**COMPLETE THIS FORM WHEN DROPPING OFF ANY  
CORRESPONDENCE AND/OR PLANS TO THE HOWARD COUNTY  
DEPARTMENT OF INSPECTIONS, LICENSES AND PERMITS COUNTER:**

Subject: Project name SINGH RESIDENCE

Project site address 11859 LINE KIRK RD FULTON, MD 20759

Building - 2017 Plot  
1/2<sup>1/2</sup> Plan revisions

**PLOT PLAN**

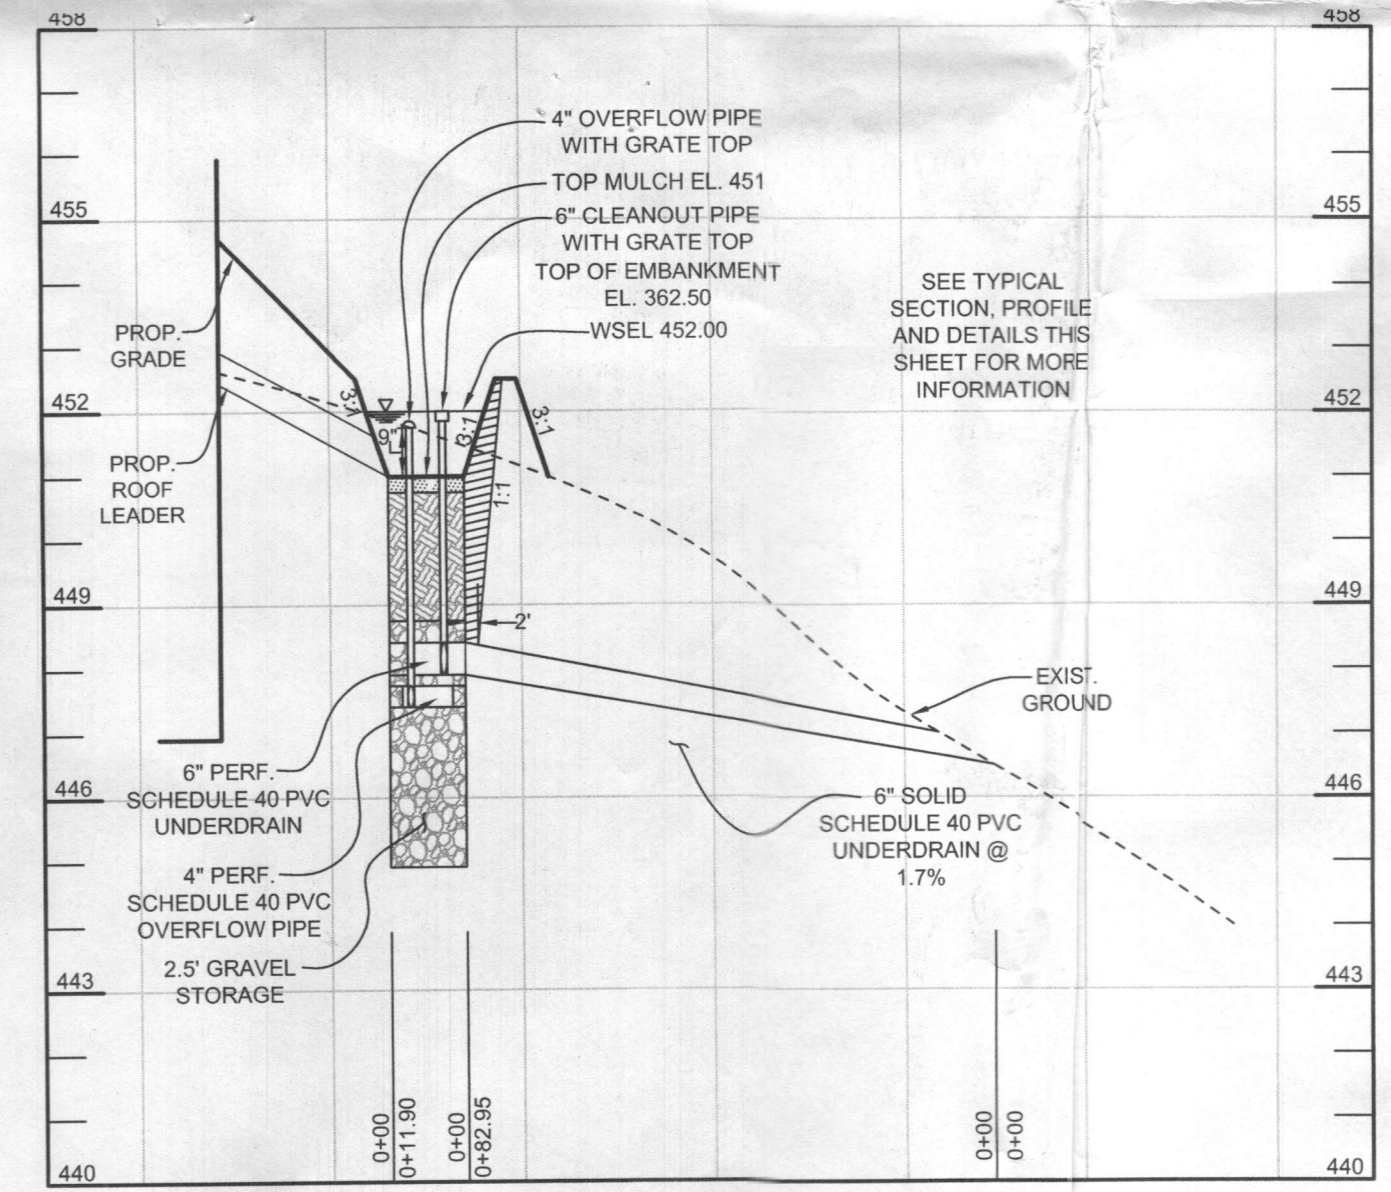
- Letter of response to address plan review comment letter
- Revised plans and/or revised details: When submitting for a complete re-review, **duplicate sets shall be submitted.**
- Letter Summarizing Changes
- Energy conservation calculations
- 2 Copies of \_\_\_\_\_ (be specific). Remove Retaining Wall @ Drive + TURNAWAY
- Health Department Request  DPZ/ DED Request  Applicant's Request
- Two sets of single family dwelling model plans to be placed on permanent file: Model name and/or # \_\_\_\_\_
- Other \_\_\_\_\_

REVISED  
 Date: 5/18/17  
 Comments: B1700074  
 Removed Retaining wall @ D/W + turnaround (paving) per Health Dept.
